London Luton Airport Expansion

**8.118 Applicant's Response to Issue Specific Hearing 4
Action 7 - Update on Road Safety Audits**

**London Luton Airport Expansion Development Consent
Order 202x**

Report title:	Stage 1 Road Safety Audit Designer's Response- M1 Junction 10
Date:	November 2023
Document Reference and Revision:	TR020001/APP/8.118
Prepared by:	Neil Scott
On behalf of:	Luton Rising

Figure 3.1: Swept Paths - Frank Lester Way / Eaton Green Road

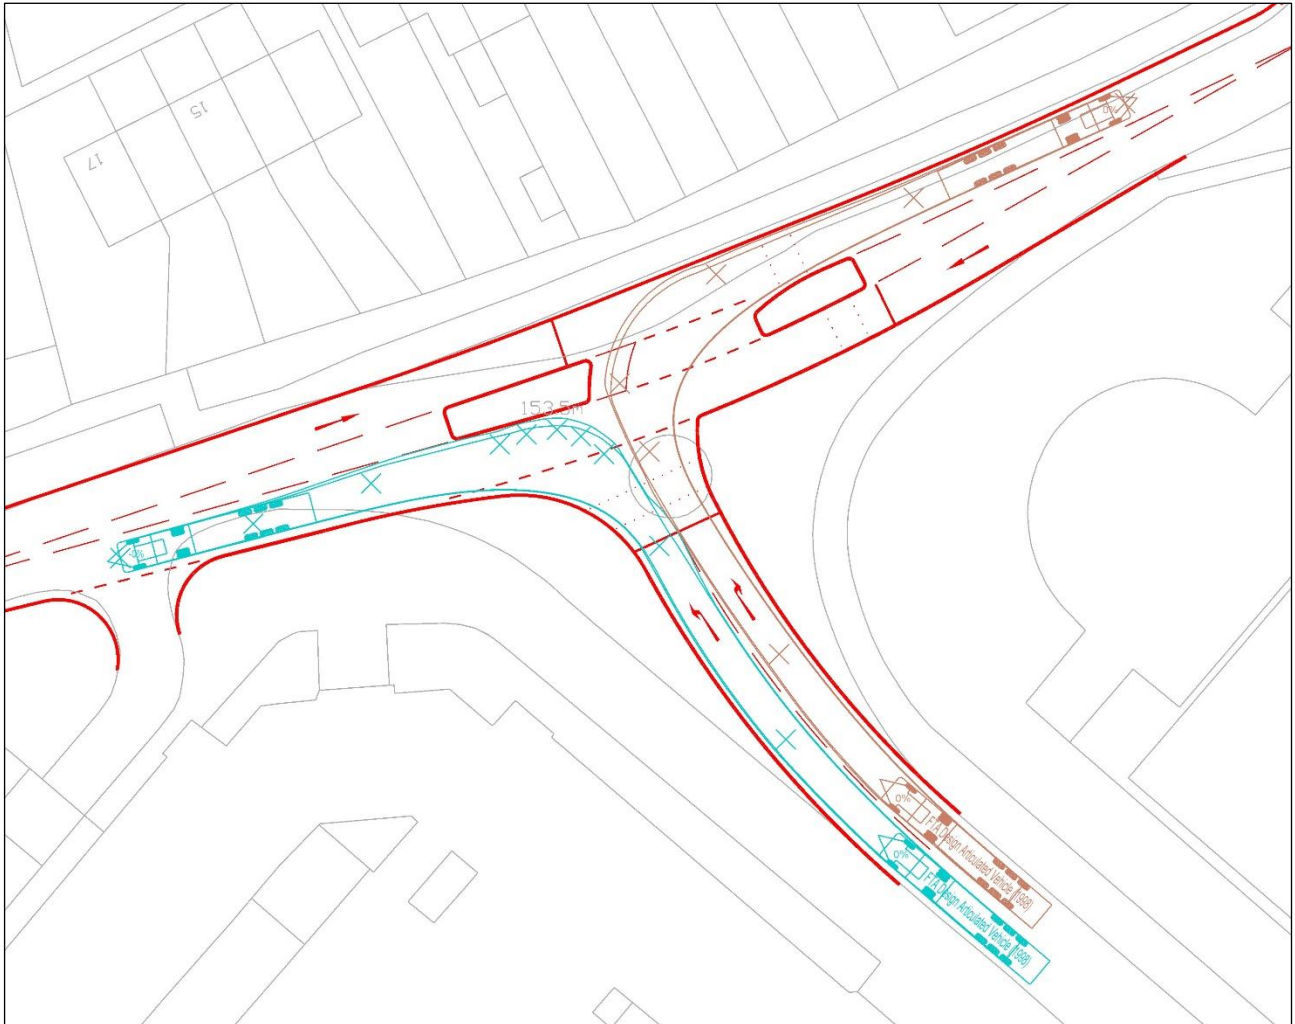
Ref.	RSA Problem	RSA Recommendation	Design Organisation Response	Overseeing Organisation Response	Agreed RSA Action
	result, they may mount the kerbs or strike street furniture, creating a hazard to other road users or pedestrians walking along the footway.	geometry of the junction amended if required.	into Eaton Green Road was achievable for vehicles including articulated HGVs and buses – see Figure 3.1	checked at subsequent design stages.	at subsequent design stages.

3.2.1 Figure 3.1 above shows the swept path analysis for 16.5m articulated HGV manoeuvres at the proposed signalised junction between Frank Lester Way and Eaton Green Road.

Figure 3.1: Swept Paths - Eaton Green Road / Lalleford Road

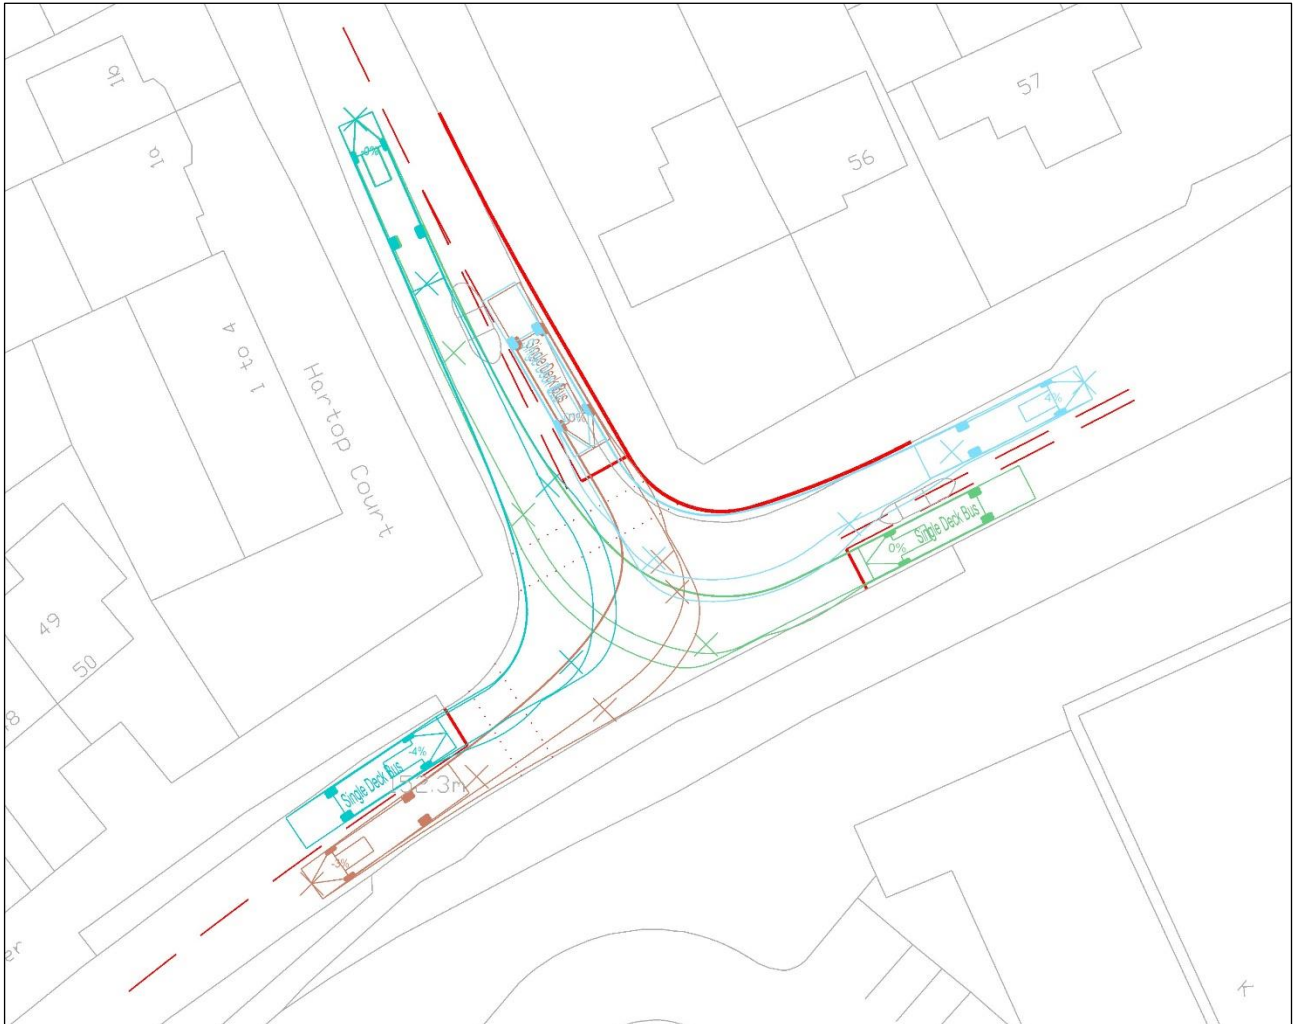
Ref.	RSA Problem	RSA Recommendation	Design Organisation Response	Overseeing Organisation Response	Agreed RSA Action
	Road is a bus route). As a result, large vehicles may mount the kerbs or strike street furniture, creating a hazard to other road users or pedestrians walking along the footway.	position of the stop lines adjusted if required.	to ensure that all manoeuvres can be accommodated without overrunning stop lines – see Figure 3.1.	checked at subsequent design stages.	at subsequent design stages.

3.2.1 Figure 3.1 above shows the swept path analysis for 12m single deck buses at the proposed signalised junction between Eaton Green Road and Lalleford Road.

Figure 3.1: Potential Pedestrian Crossing Improvements

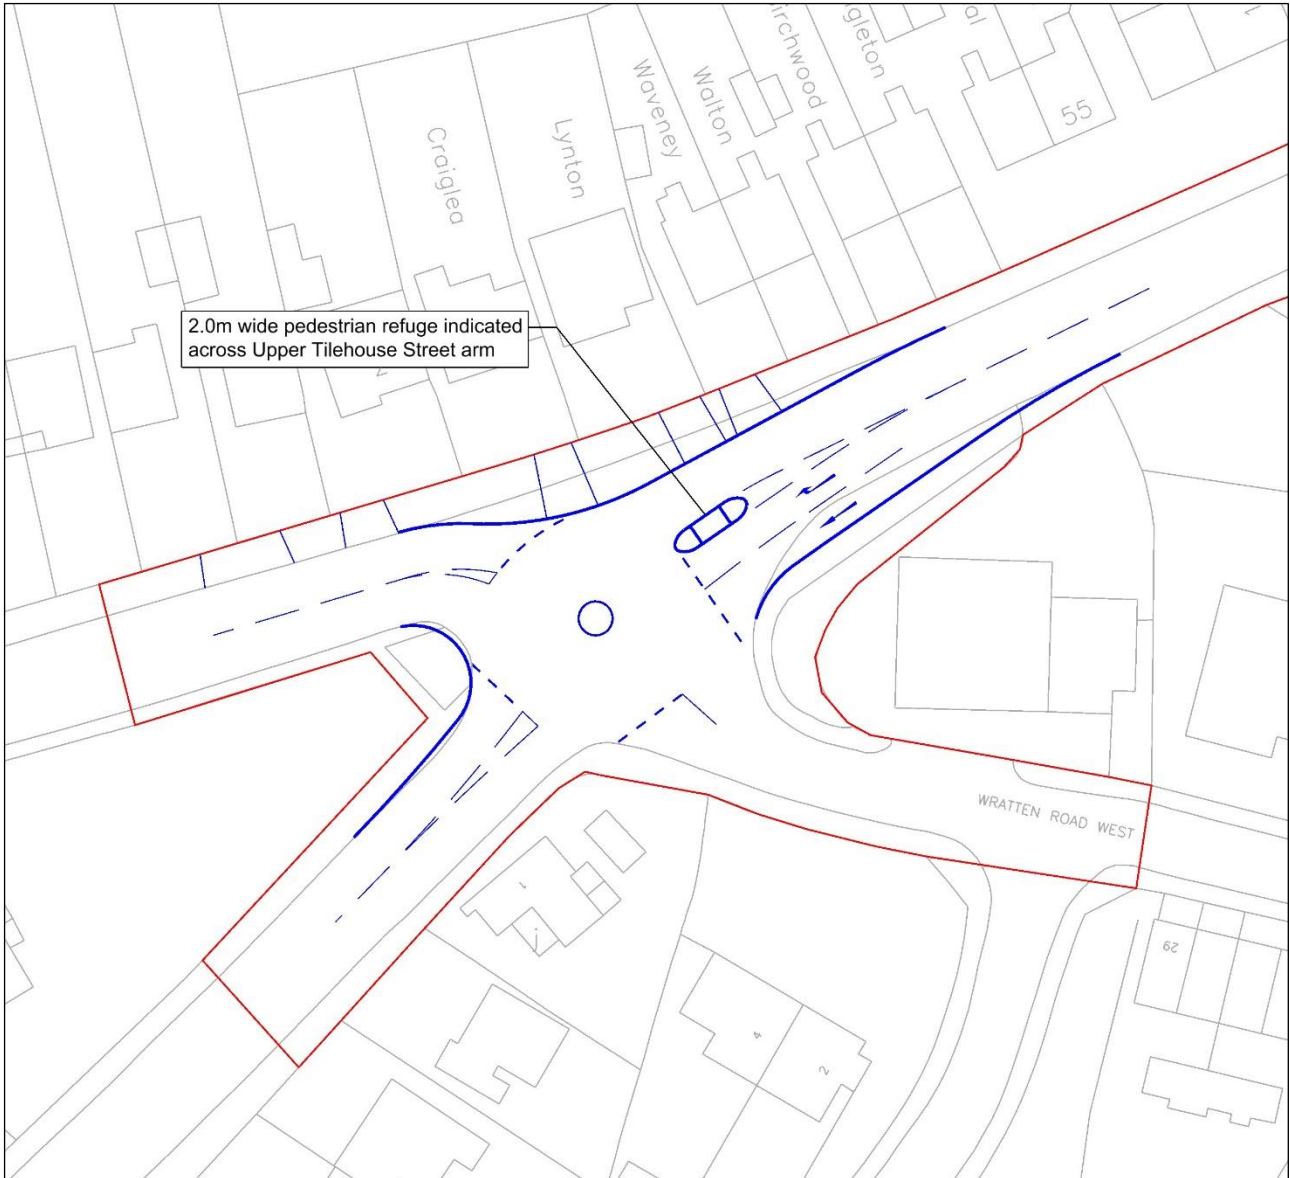
3.2	The widening to two lanes could make crossing movements more hazardous for pedestrians, especially at peak-times when traffic flows are likely to be high. This could increase the risk of pedestrians being struck by vehicles.	An uncontrolled pedestrian crossing point should be provided, with a wider physical central island specified.	Accepted. An uncontrolled crossing on Upper Tilehouse Street has been incorporated into the proposed layout as shown on Figure 3.1.	Disagree: At detailed design stage it is too late to address this issue. Pedestrian crossing facilities must be addressed at this stage in line with HCC policy.

3.2.1 Figure 3.1, below, shows an indicative arrangement to provide a pedestrian crossing on the eastern arm of the mini-roundabout.

3.2.2 Figure 3.1 shows an indicative revised junction arrangement which incorporates a pedestrian refuge across Upper Tilehouse Street. Existing residential dropped kerb accesses are also highlighted along the northern side of Upper Tilehouse Street and Pirton Road, in the vicinity of the junction.

Figure 3.1: Existing Tree Locations – A602 Park Way

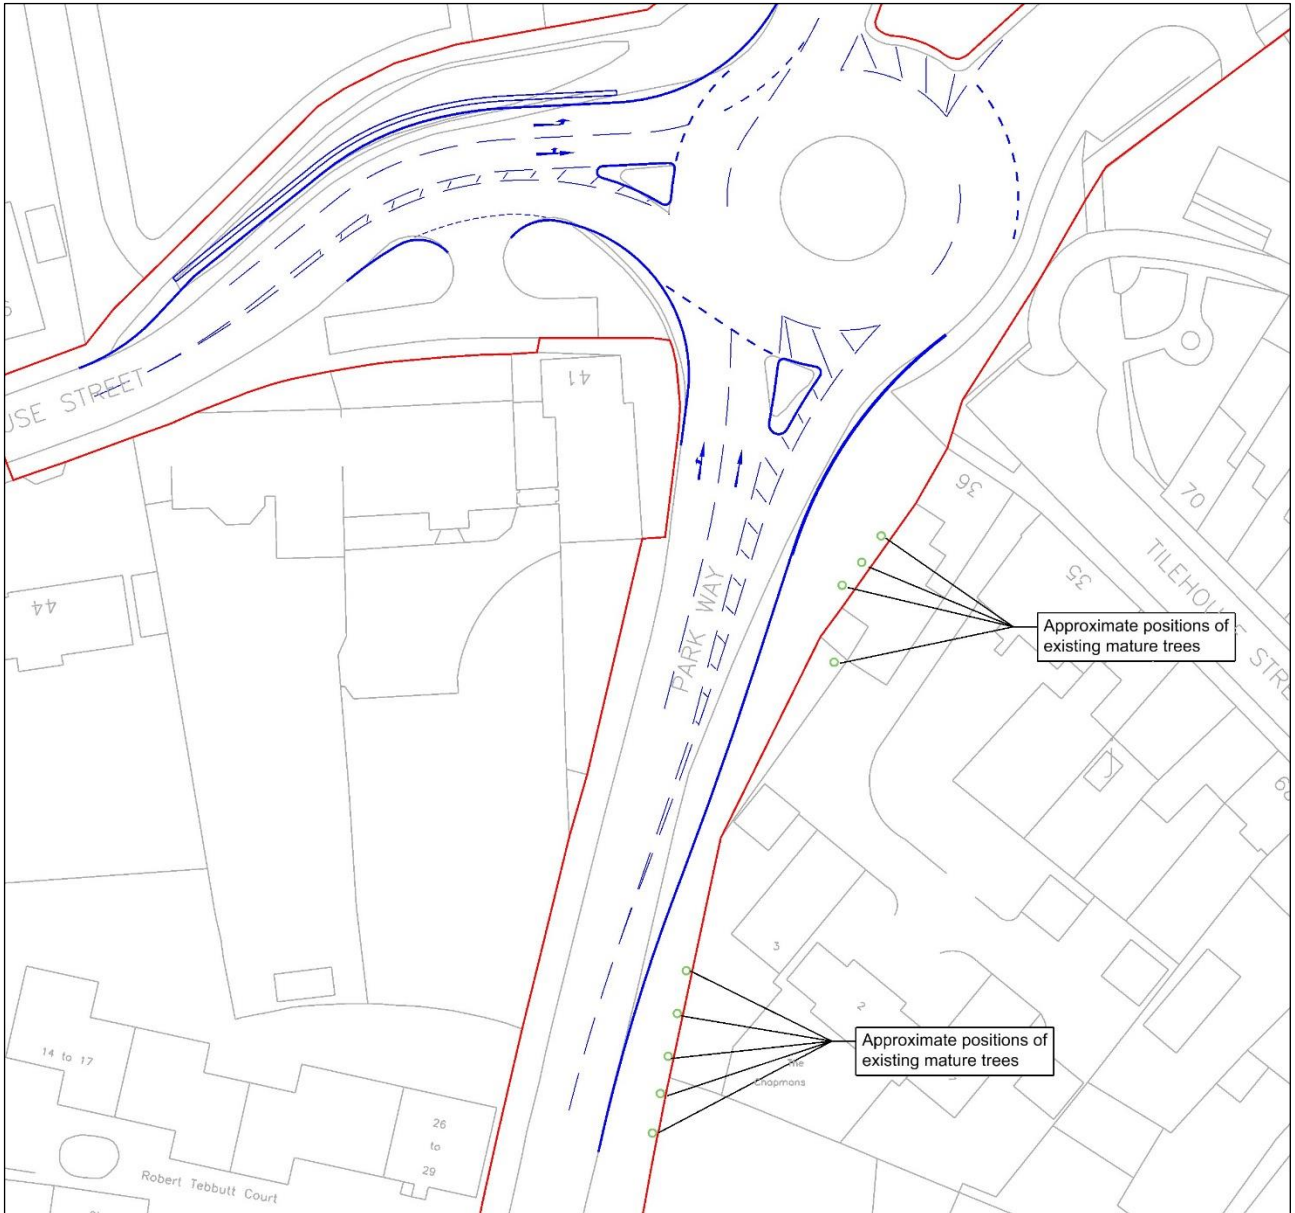
3.2	There are mature trees, dense vegetation, signs and lamp columns on the eastern side of Park Way, that could be impacted by the carriageway widening works. If these items are positioned close to the edge of carriageway, there could be an increased risk of them being struck by errant vehicles, resulting in injury to road users.	It should be ensured that any dense vegetation and mature trees are removed if they are likely to be positioned close to the edge of carriageway and other items of street furniture relocated as necessary.	Accepted. Figure 3.1 shows the indicative locations of mature trees in the area where road widening is proposed. The mature trees are within the Hitchin Conservation Area but do not have Tree Preservation Orders. They are generally located close to the highway boundary and would not be close to the widened road carriageway edge. It is not therefore expected	Disagree: Mature trees are unlikely to be removed to make way for these works. Further scheme detail will be required to show which trees are affected: This may change the nature of the scheme, easily leading to it being undeliverable. In short, the designer organisation response is not feasible/practical solution.

3.2.1 Figure 3.1, below, shows the existing tree locations along the eastern side of A602 Park Way, together with the proposed Order Limit.

Figure 3.1: Existing Tree Locations

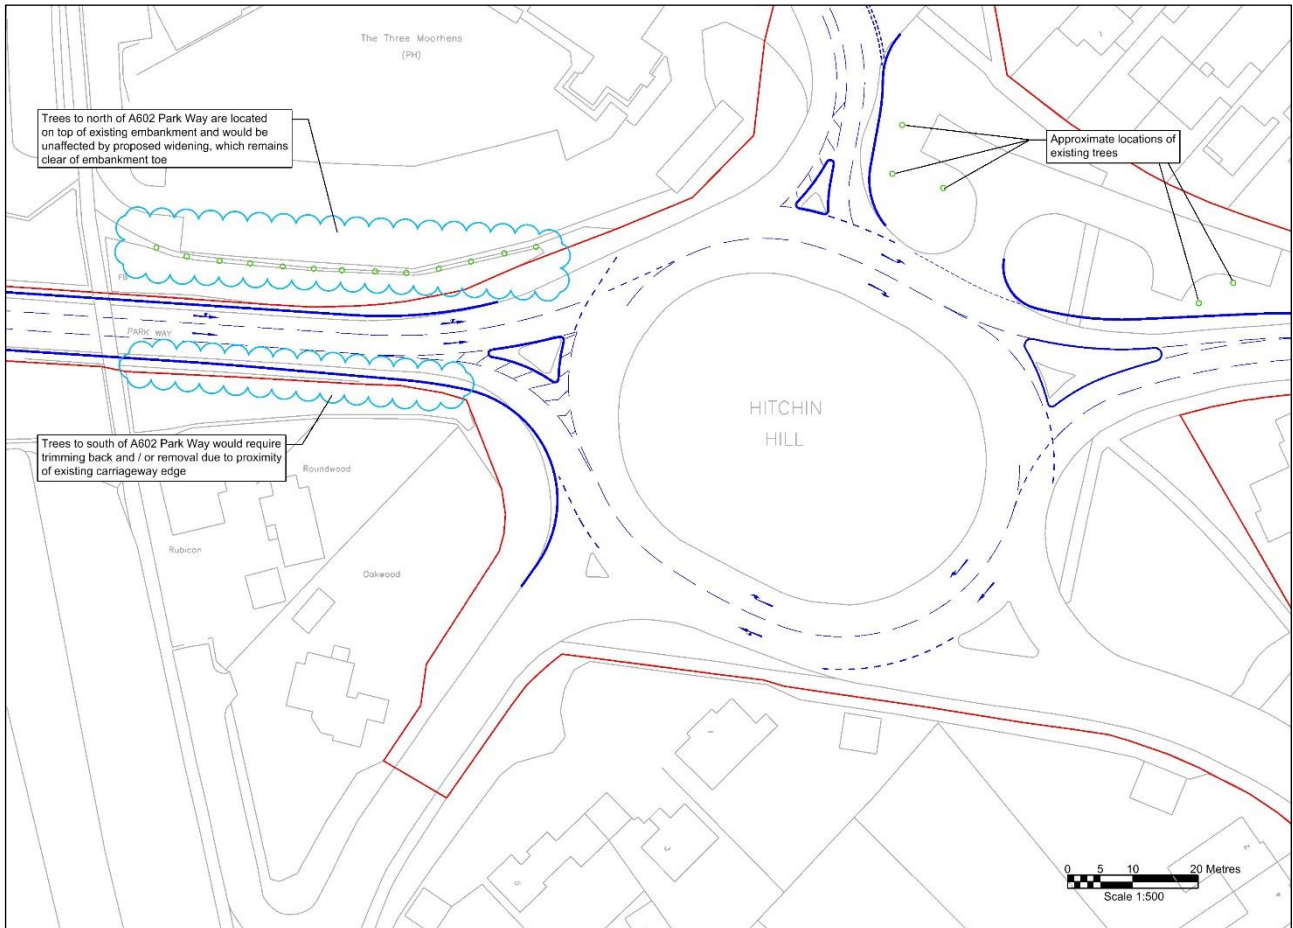
3.2	There are mature trees, dense vegetation, signs and lamp columns on Park Way, that could be impacted by the carriageway widening works. If these items are positioned close to the edge of carriageway, there could be an increased risk of them being struck by errant vehicles, resulting in injury to road users.	It should be ensured that any dense vegetation and mature trees are removed if they are likely to be positioned close to the edge of carriageway and other items of street furniture relocated as necessary.	Accepted. Figure 3.1 shows the indicative locations of mature trees in the area where road widening is proposed. The trees are not within the Hitchin Conservation Area (HCA) and do not have Tree Preservation Orders. The trees on the north side of A602 Park Way are on an embankment and are set back from the road carriageway edge where it is not therefore expected that the trees would need removing. On the south side, it is likely that some trees	Disagree: Mature trees are unlikely to be removed to make way for these works. Further scheme detail will be required to show which trees are affected: This may change the nature of the scheme, easily leading to it being undeliverable. In short, the designer organisation response is not feasible/practical.

3.3	<p>There are numerous heavy-duty items of street furniture, such as lamp columns, utility cabinets and a telegraph pole, in addition to mature trees, that will be impacted by the carriageway widening works. If these items are positioned close to the edge of carriageway, there could be an increased risk of them being struck by errant vehicles, resulting in injury to road users.</p>	<p>It should be ensured that street furniture is relocated, and mature trees removed as necessary as part of the widening works.</p>	<p>Accepted. Figure 3.1 shows the indicative locations of mature trees in the area where road widening is proposed. The trees are not within the Hitchin Conservation Area (HCA) and do not have Tree Preservation Orders.</p> <p>Nevertheless, there is flexibility in the design of the Hitchin Hill approach to move the kerblines away from the closest trees by reducing the lane widths and/or the central hatched area – this is shown on Figure 3.1.</p> <p>The mature trees on the north side of the A602 westbound approach are</p>	<p>Disagree: Mature trees are unlikely to be removed to make way for these works. Further scheme detail will be required to show which trees are affected: This may change the nature of the scheme, easily leading to it being undeliverable. In short, the designer organisation response is not feasible/practical.</p>

3.2.1 Figure 3.1, below, shows the approximate locations of existing trees in the vicinity of the A602 Park Way / Hitchin Hill arms of the junction, together with a potential minor amendment to the Hitchin Hill arm of the junction to minimise potential impact on trees to the east.
